**ISSUE:** Certificate of Appropriateness for alterations (small cell facility)

**APPLICANT:** AT&T Mobility

**LOCATION:** Old and Historic Alexandria District  
Dominion Energy utility pole near 1011 North Washington Street

**BAR #2022-00069**

Figure 2 - Design A-8 approved by the City Council

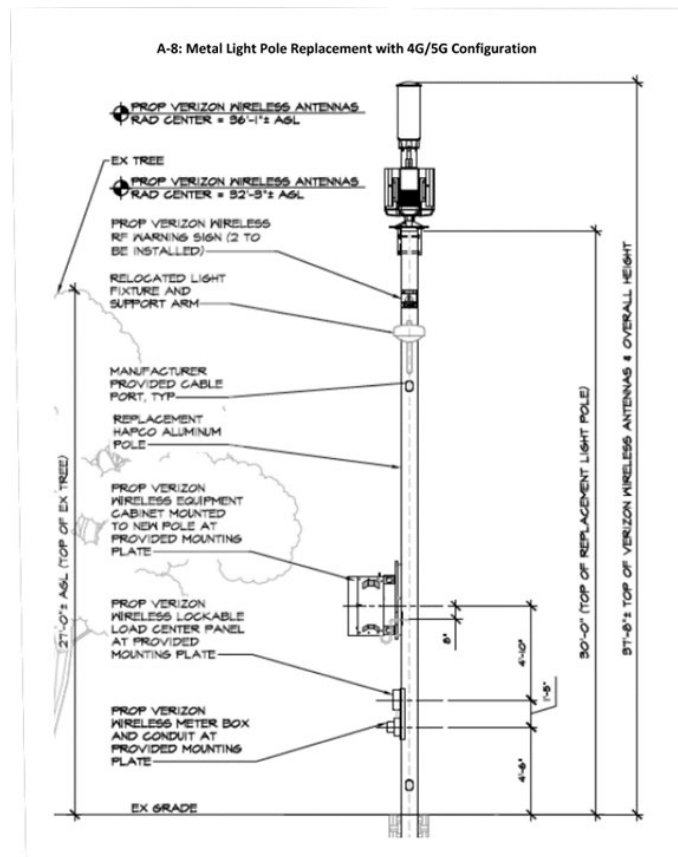
The overall height of the new pole including the small cell facility is 38'-5". BAR staff has no objection to the taller metal pole or the installation of the small cell facility in this location and finds that painting the equipment the same color as the pole will make them less obvious. The existence of utility poles and overhead wires, street signs, and light poles are part of the urban streetscape, and staff does not believe that the installation of the taller pole with the small cell equipment will adversely impact existing viewsheds.

**PROPOSED  
ELEVATION  
VIEW**

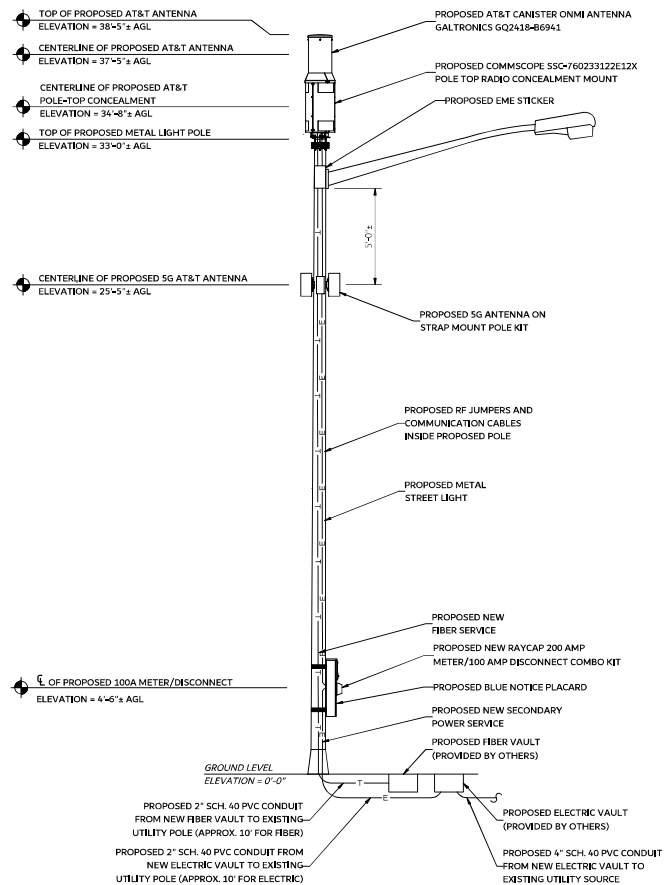
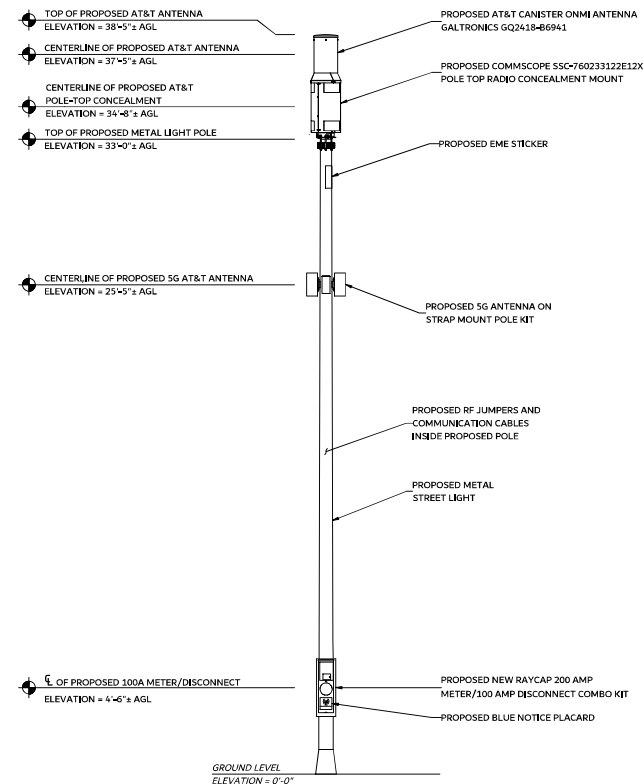
- Drawing C-2, it is unclear if the new pole will be tapered like the existing pole, or be one diameter straight up. Please confirm. If it is different, is there a structural limitation? **See attached specs of pole being installed by Dominion. These poles were specifically designed by Dominion to structurally hold the maximum weight of equipment the carriers would want to install.**

- The center of the pole is now 9'2" from the property line, where there is a brick wall/metal fence. The proposed pole center line is shown 4'-8". How much sidewalk clearance does this leave (may be a city question)? From a practical perspective, is this enough sidewalk clearance? Also, similar to question above, will this appear out of line with other light poles down the street? **For the most part Dominion would install the pole in the same exact location as the old pole to keep in line with the other poles. If that isn't the case it would be installed directly next to the existing pole still keeping in line with other poles on the street. As stated Dominion takes into account if there is a possibility of any clearance issues.**
